Interview Summary	Application No. 09/911,614	Applicant(s) KOUNO ET AL.
	Examiner Michael K. GRAY	Art Unit 3746

Date of Interview: 21 October 2003.

FIG. 2.

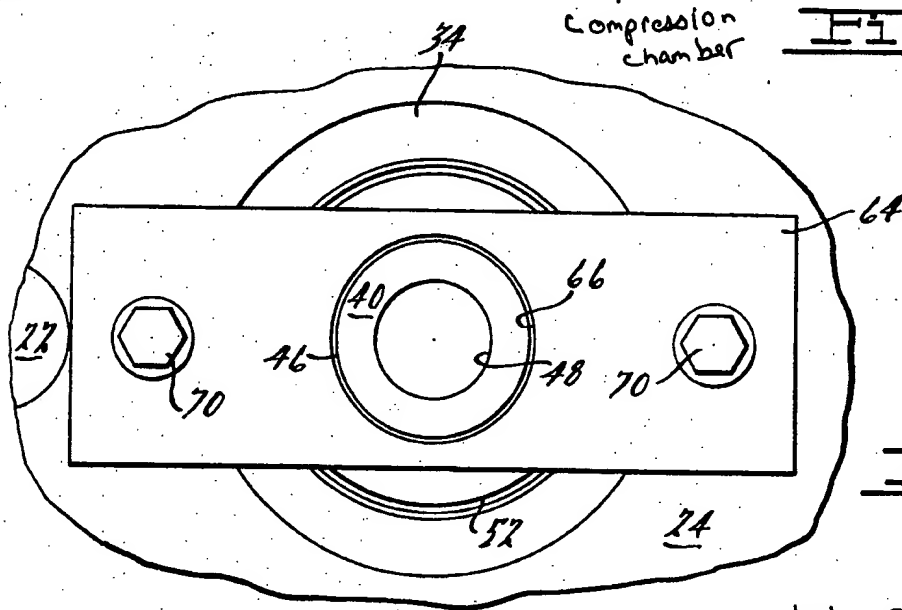
The examiner reiterated discussion with his supervisor regarding the Amendment filed September 21, 2003. An information disclosure statement would be required from the applicants if the applicants desire that the prior art discussed in the specification to be considered. In the drawings, in Figure 1a, lead lines should be provided elements 2 and 3 or the reference numerals should be placed on the applicable elements (37 C.F.R. 1.84 (q)). Other drawing figures should be reviewed in the same light, especially Figures 2, 6 and 21. In independent claims 2 and 13, examiner indicated more language is needed to define a gap which exists between a section of the projection portion and the valve seat. In claim 5, line 14, "provided the end plate" should be changed to --provided in the end plate--. With regard to claim 13, it was discussed whether the claimed "spherical portion" was the proper term and if the claimed portion as shown in Figure 2 (element 17a) is really spherical.
